MODEL
2018MY
Optima (JFa)

NUMBER
182 (Rev 1, 1/11/2018)

TECHNICAL SERVICE BULLETIN

SUBJECT: SERVICE ACTION: FLOOR CONSOLE INNER PANEL
INSPECTION & CORRECTION/REPLACEMENT (SA328)

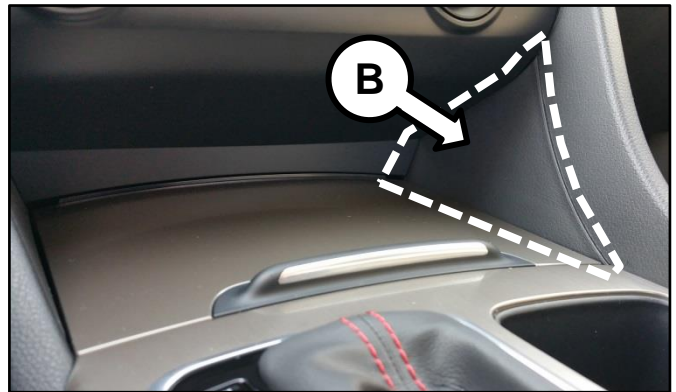
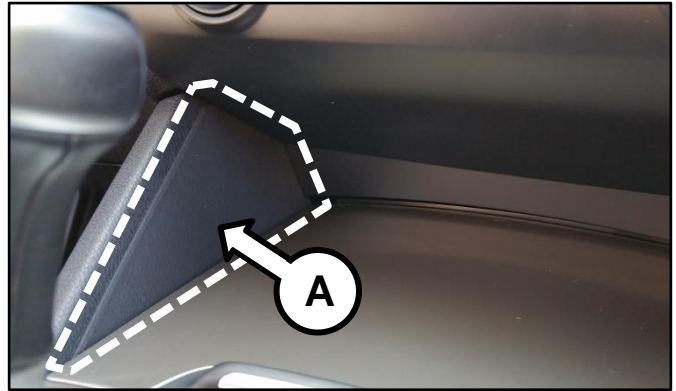
1. Inspect both left and right inner side panels (A) & (B) of the floor console for any sign of surface peeling.
 - If neither left nor right panels are peeling, proceed to Solution Application Procedure below to apply a corrective spray solution.
 - If one or both panels is/are peeling, proceed to the Replacement Procedure on page 3 of this bulletin.

1. Take the provided solution bottle and shake well before use.
2. Lightly dampen a clean microfiber towel with the provided solution by fully spraying a section of the towel about four (4) times.
3. Gently rub the damp section of the towel horizontally onto the surface of the floor console inner side panels (A) & (B) and allow solution to dry.

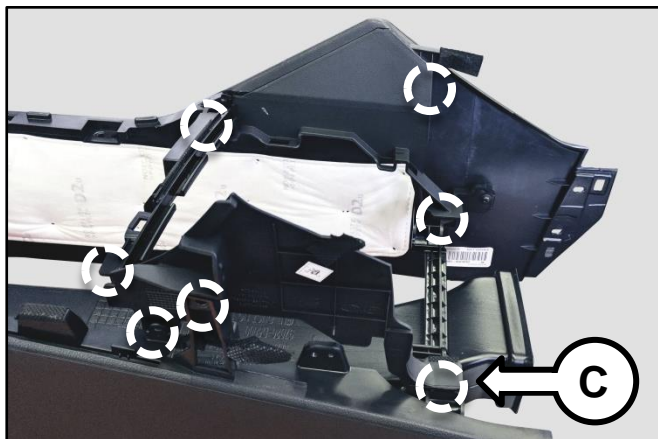
2. Remove and set aside (for reuse) the seven (7) panel retaining bolts (C) and remove both of the inner floor console (LH & RH) side panels (A) & (B).

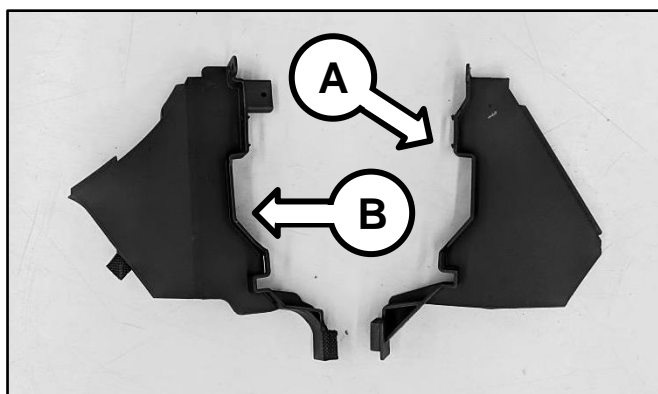
3. Install the new improved left and right inner side panels (A) and (B) onto the floor console in the reverse order of removal.
